RE: HARLOW STAGE 6 - AMENDMENTS TO CONSTRUCTION PLAN APPROVAL

RE: HARLOW STAGE 6 - CONSTRUCTION PLAN APPROVAL

**HARLOW ESTATE
STAGE 6
ROAD AND DRAINAGE
FACE PLAN - SHEET 1
WYNDHAM CITY COUNCIL
SIG GROUP**

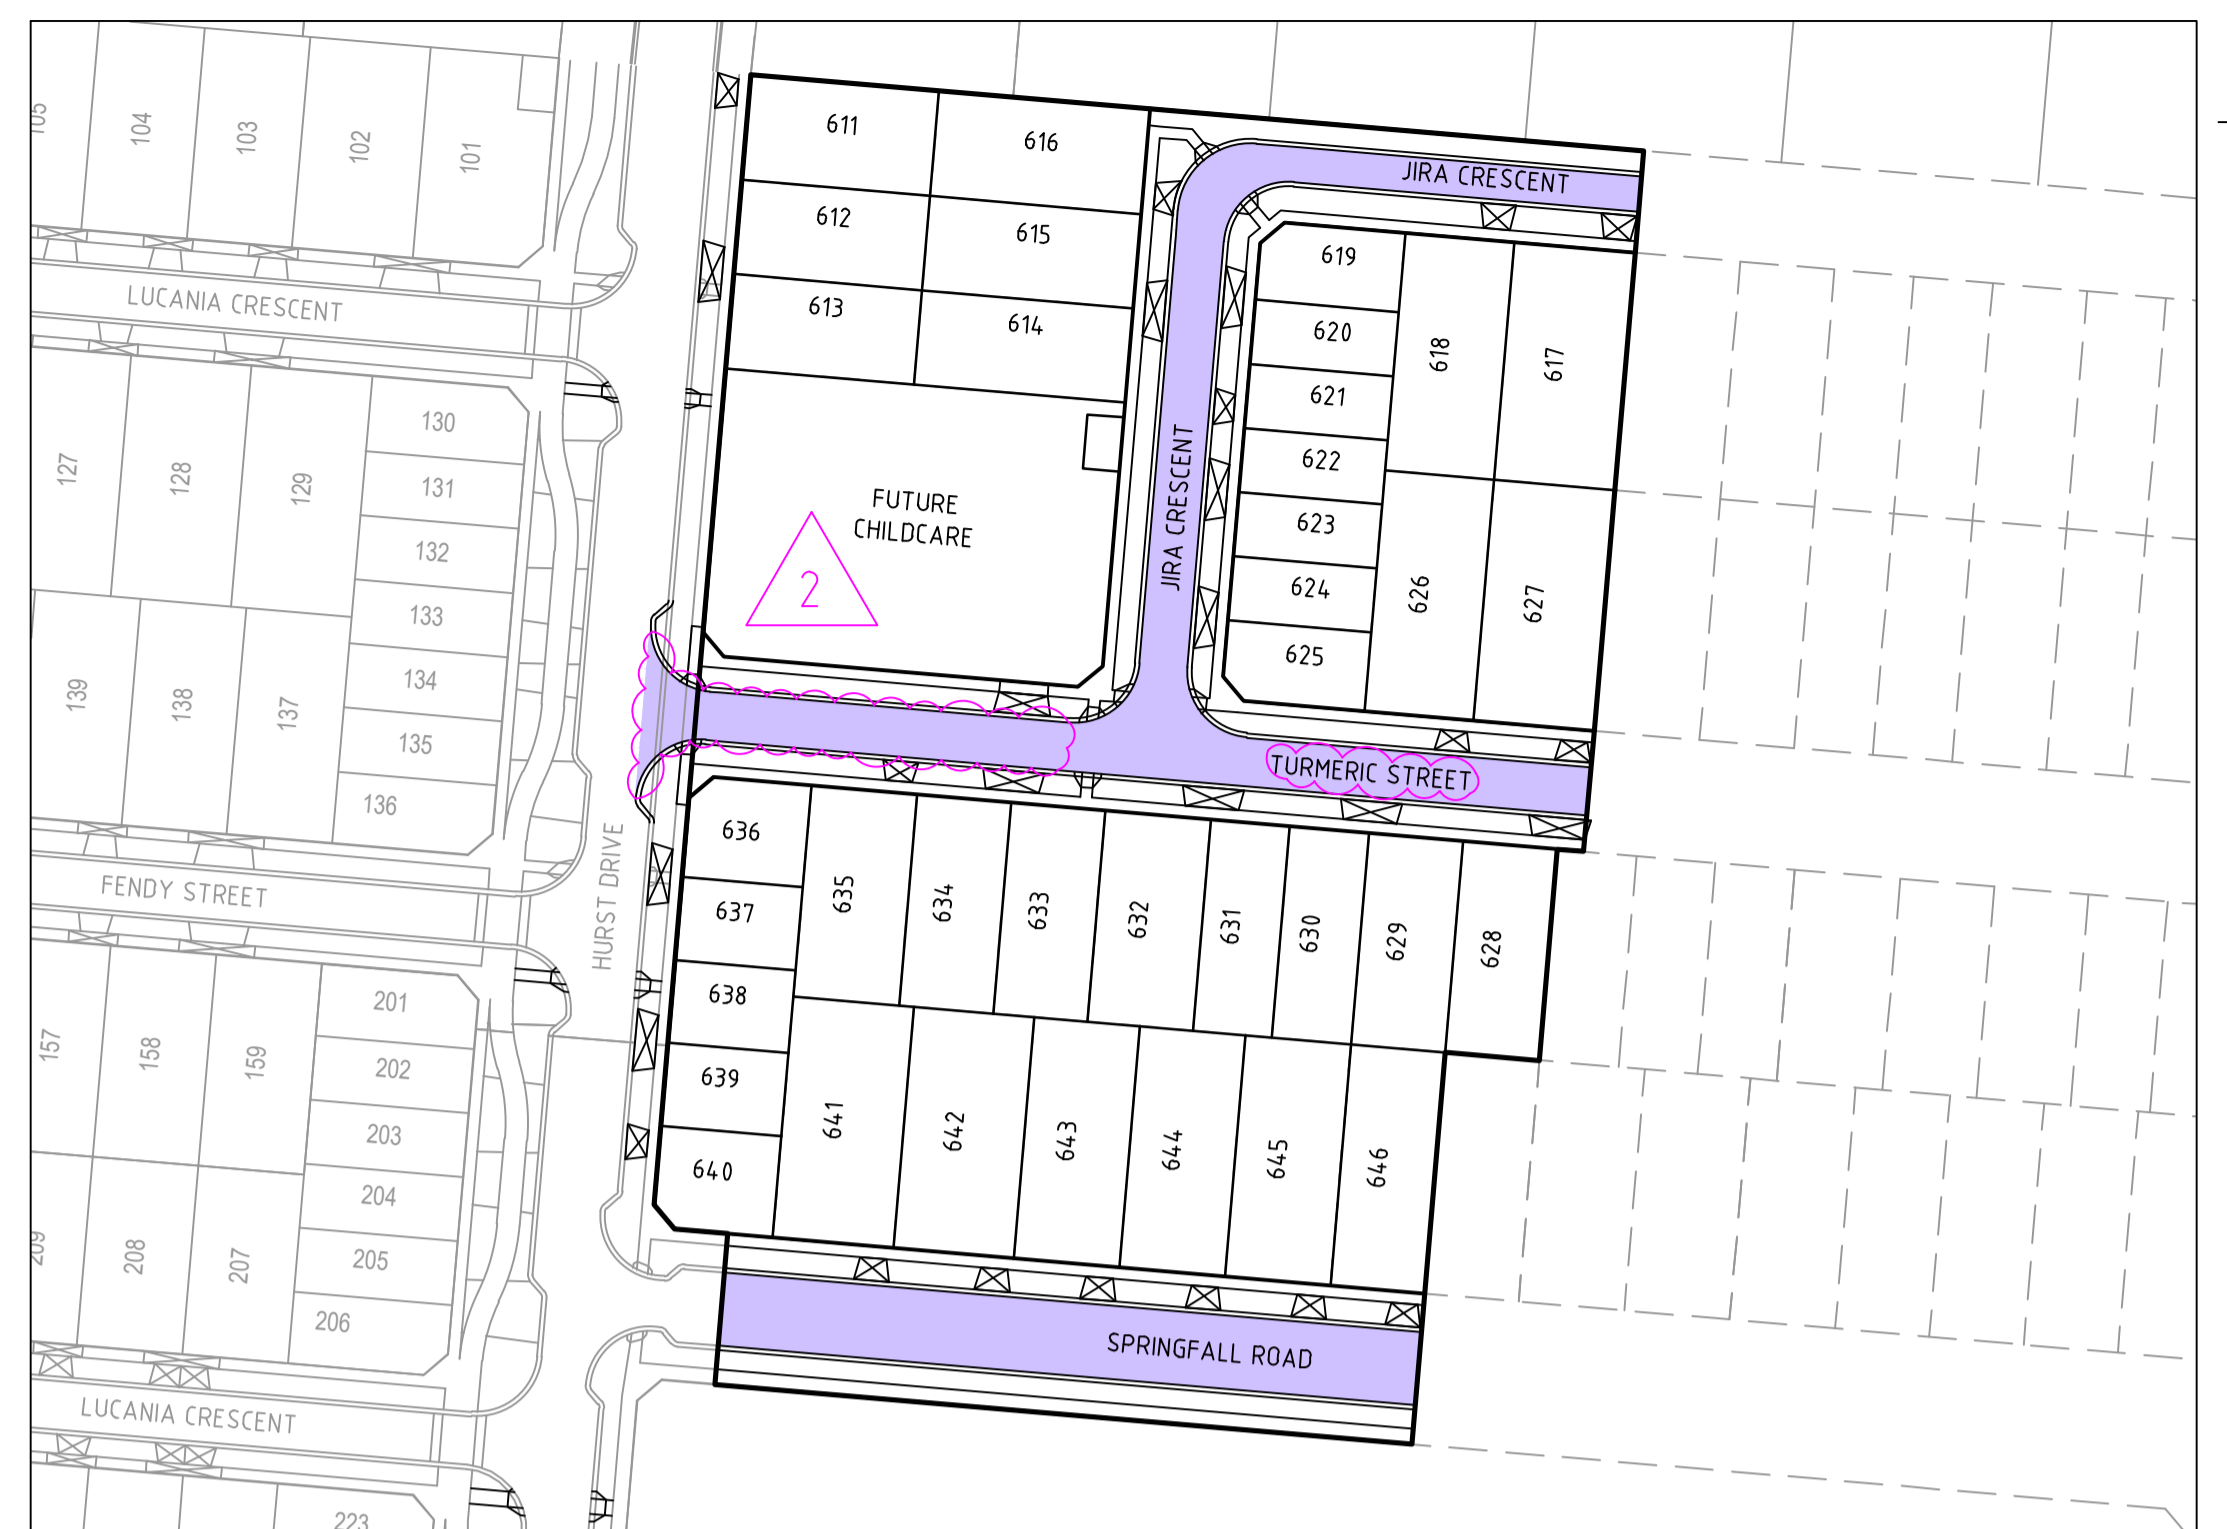
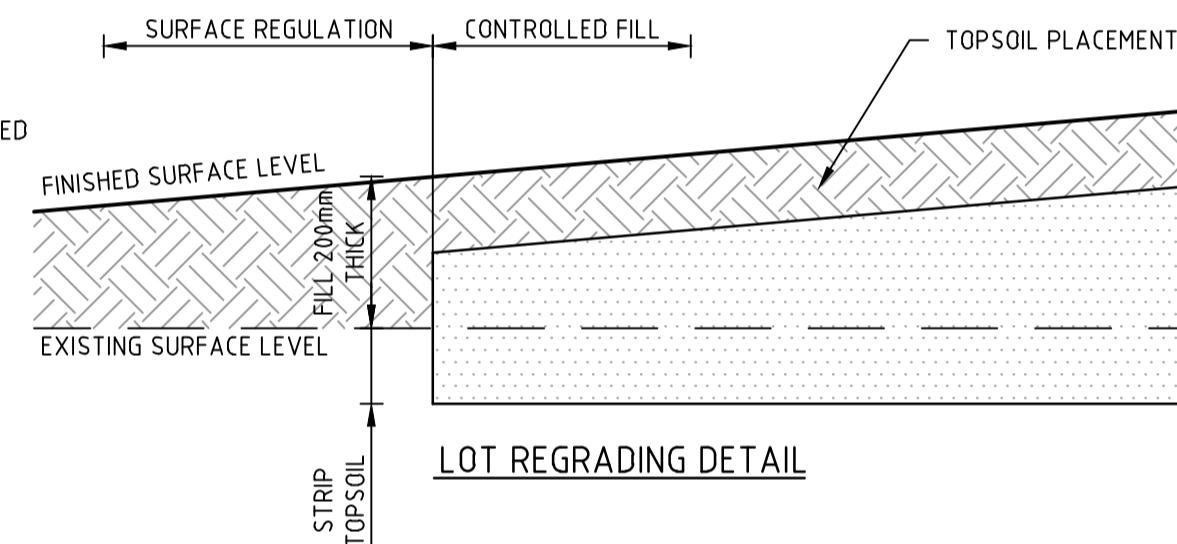
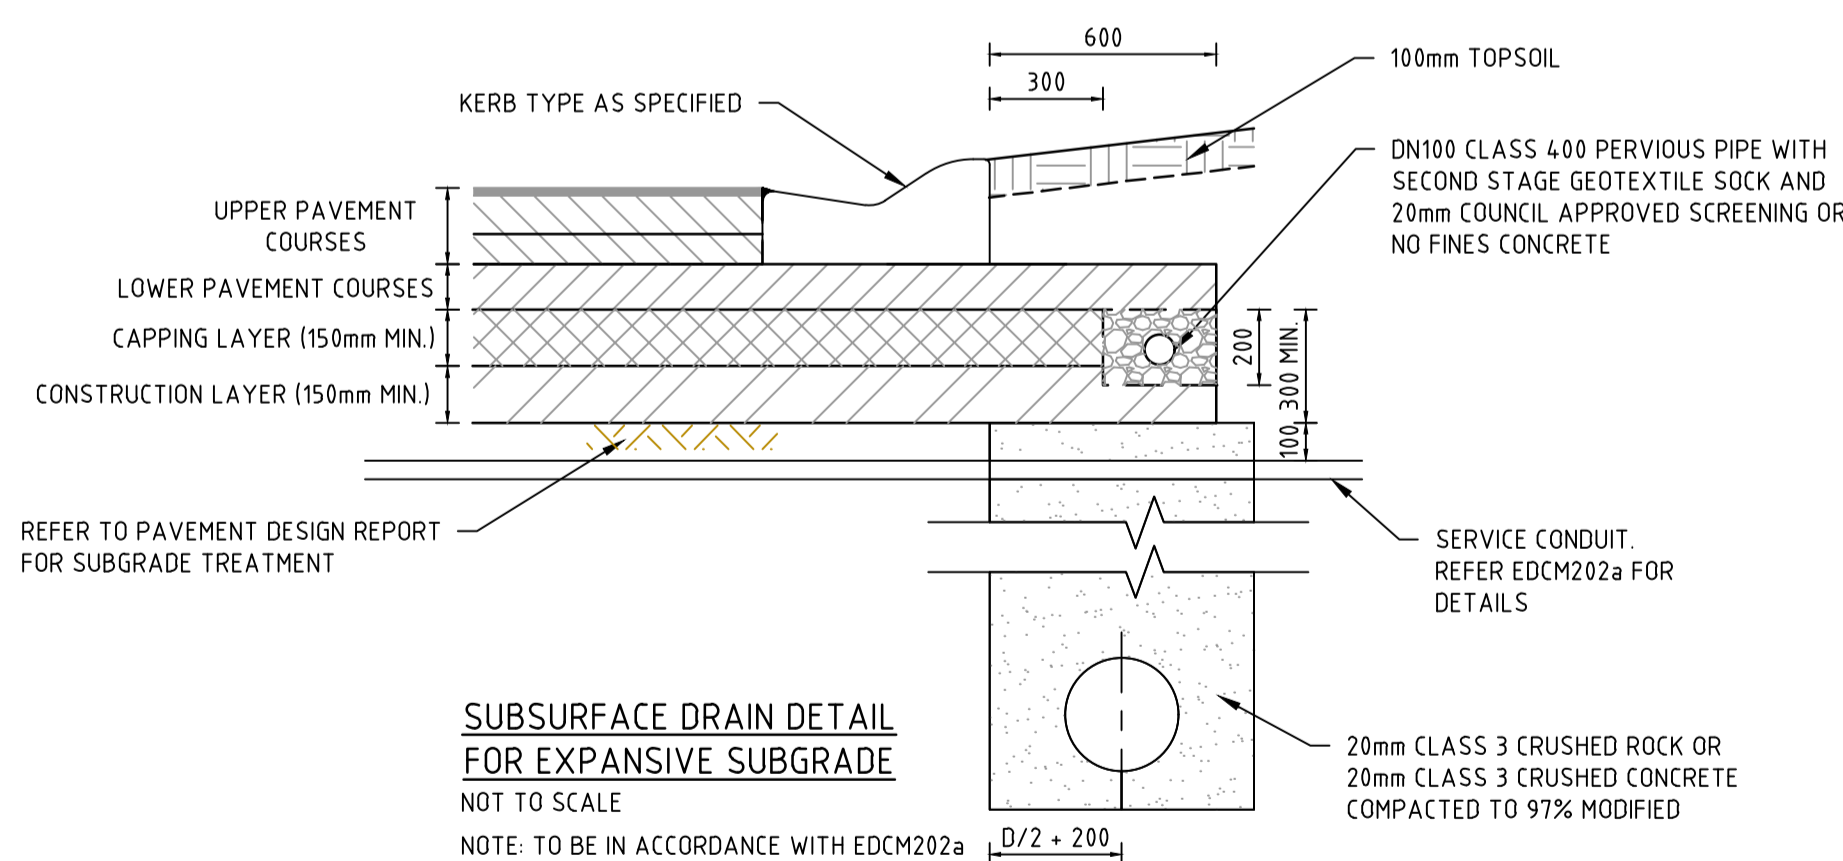
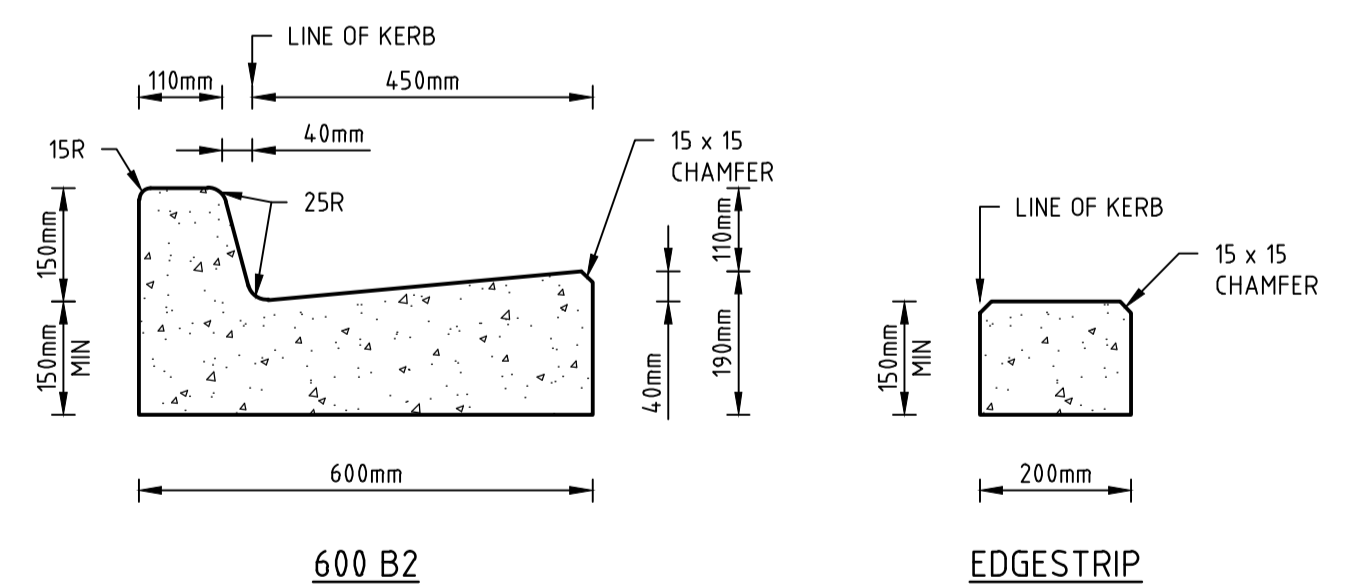
2	ROAD NAME & PAVEMENT PROFILE AMENDED	G.K	01/10/25
1	PAVEMENT TYPE B ADDED, PAVEMENT HATCH AMENDED	G.K	23/07/25
0	ISSUED FOR CONSTRUCTION	G.K	19/03/25
C	ROAD TYPE TABLE & SPRINGFALL ROAD PAVEMENT TYPE AMENDED	G.K	18/12/24
B	ISSUED FOR TENDER	G.K	16/12/24
A	ISSUED TO COUNCIL	G.K	01/11/24
Rev	Amendments	Approved	Date

CONSTRUCTION Drg No 309442CR800 Rev 1

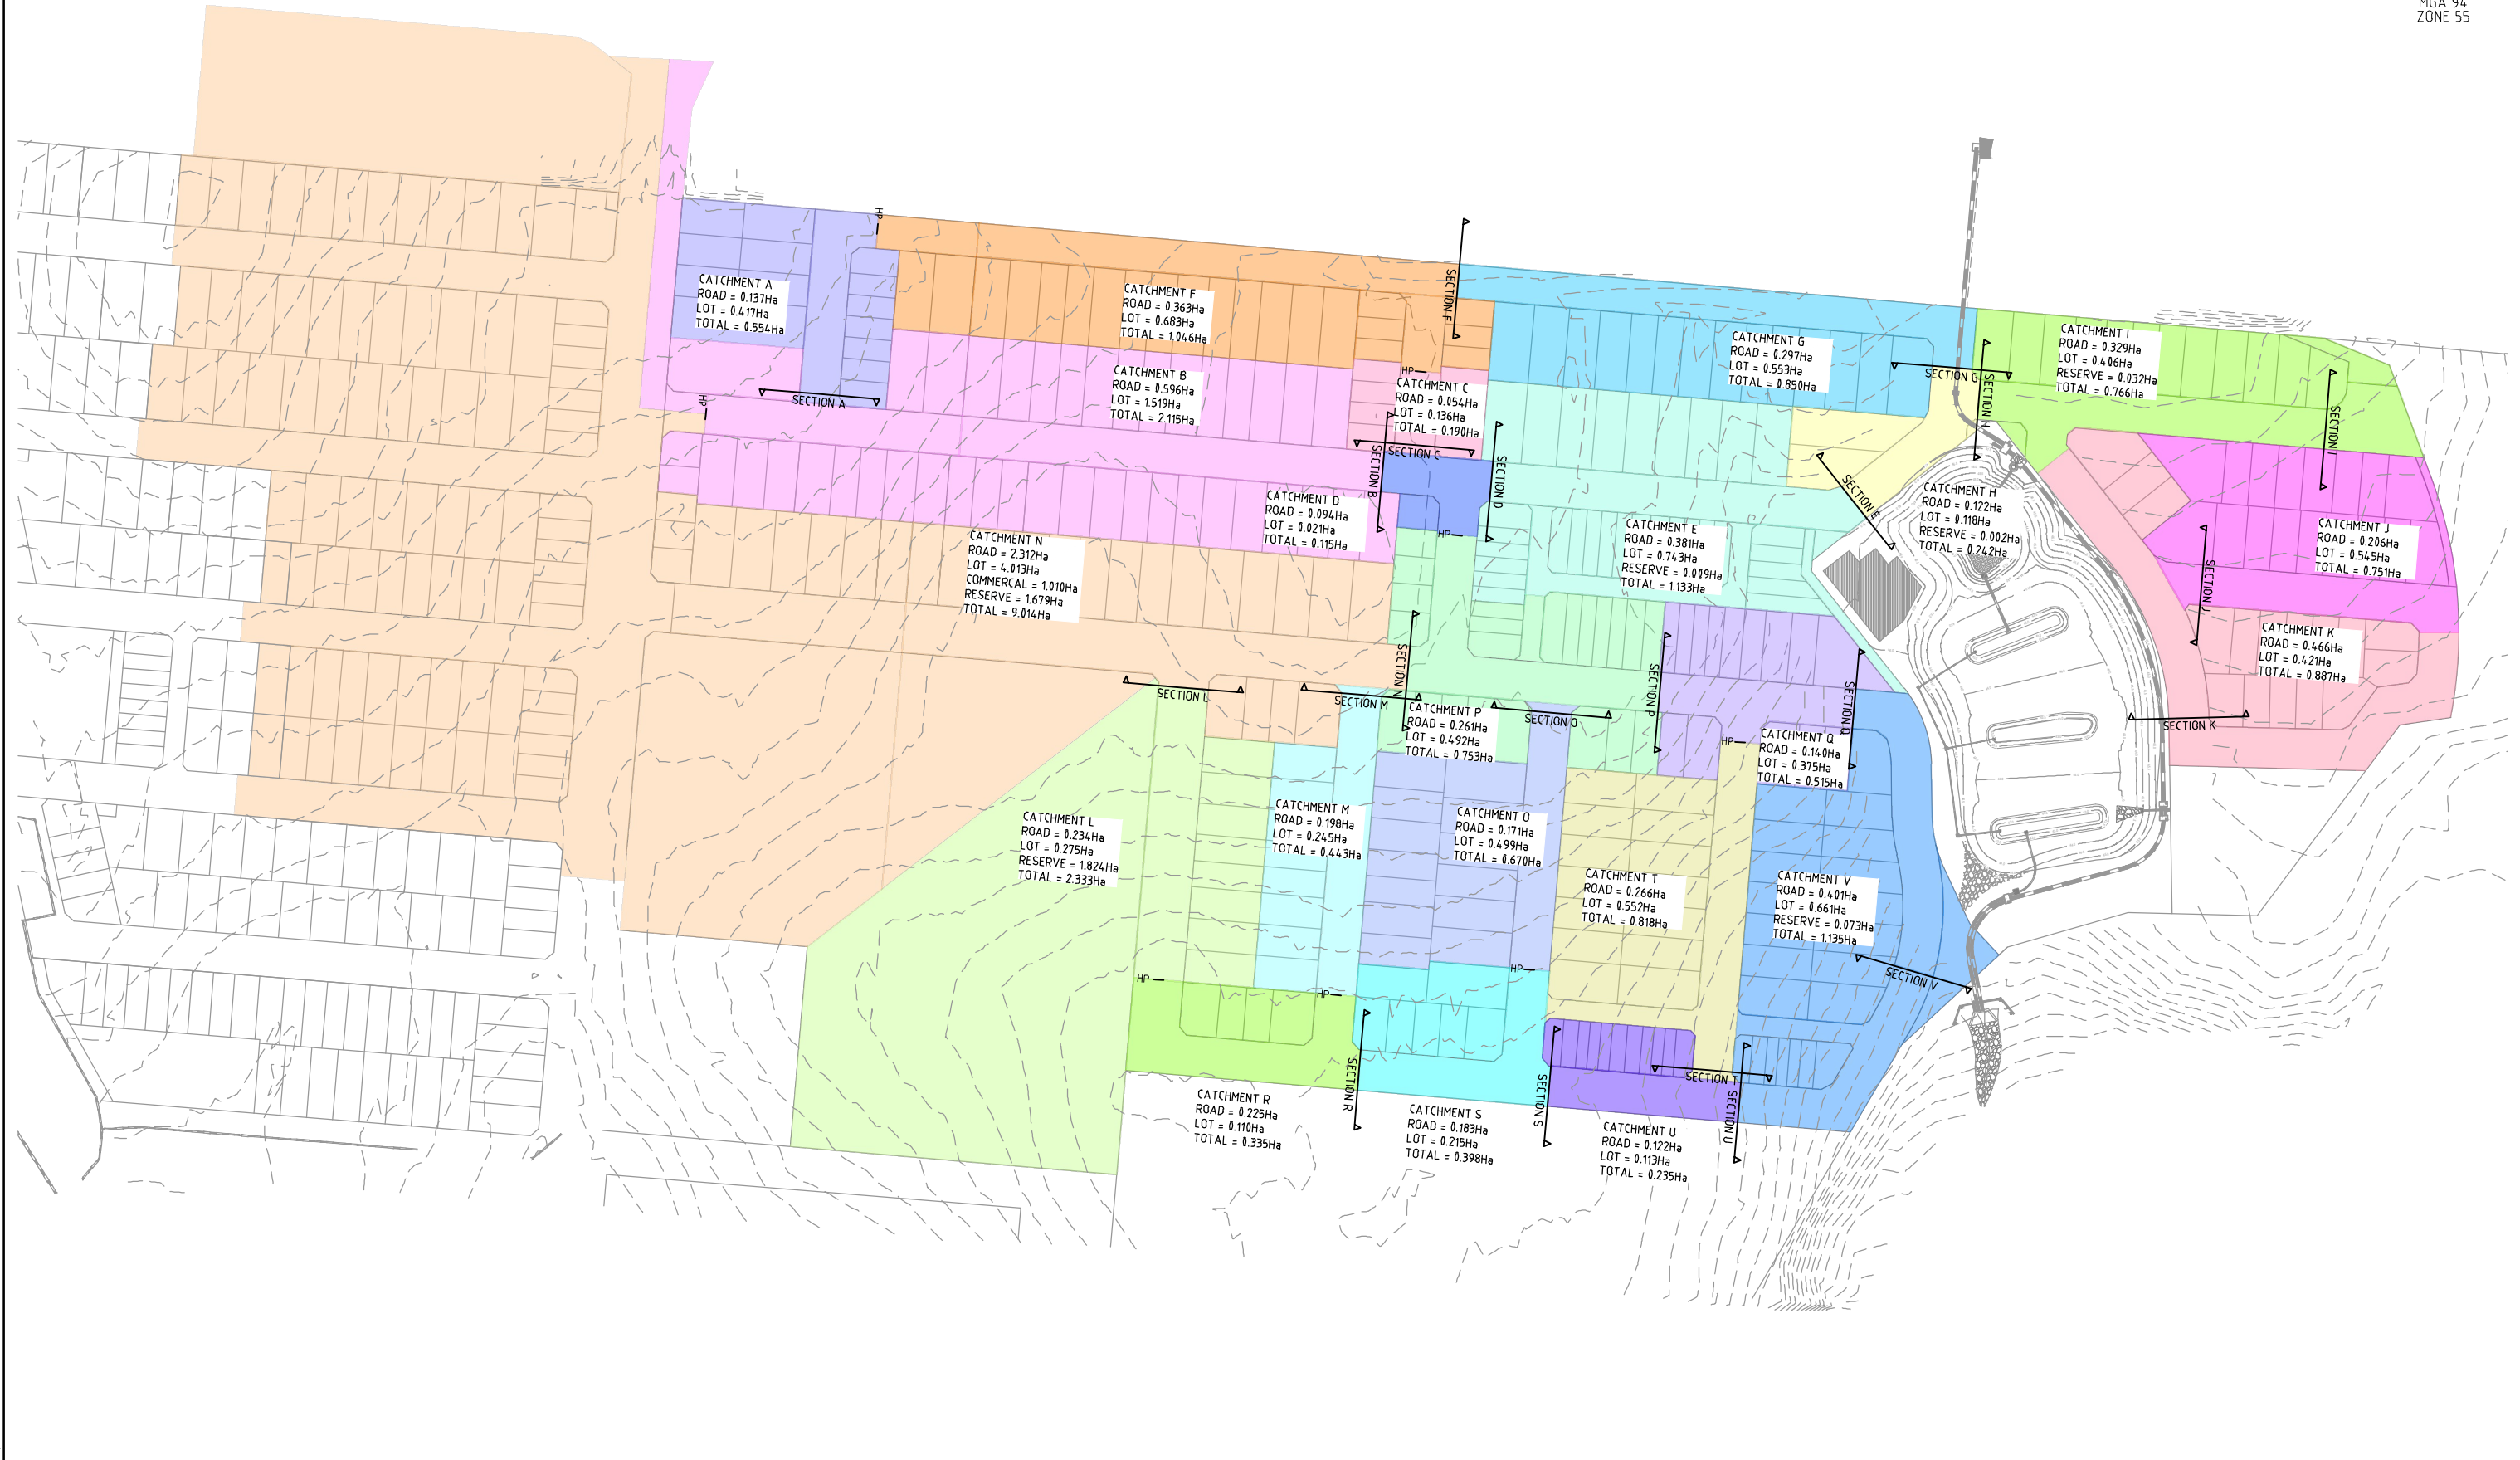
Rev	Amendments	Approved	Date
1	ROAD NAME AMENDED	G.K	01/10/25
0	ISSUED FOR CONSTRUCTION	G.K	19/03/25
D	SIGNAGE ADDED	G.K	28/01/25
C	LINEMARKING LEGEND AMENDED	G.K	18/12/24
B	ISSUED FOR TENDER	G.K	16/12/24
A	ISSUED TO COUNCIL	G.K	01/11/24
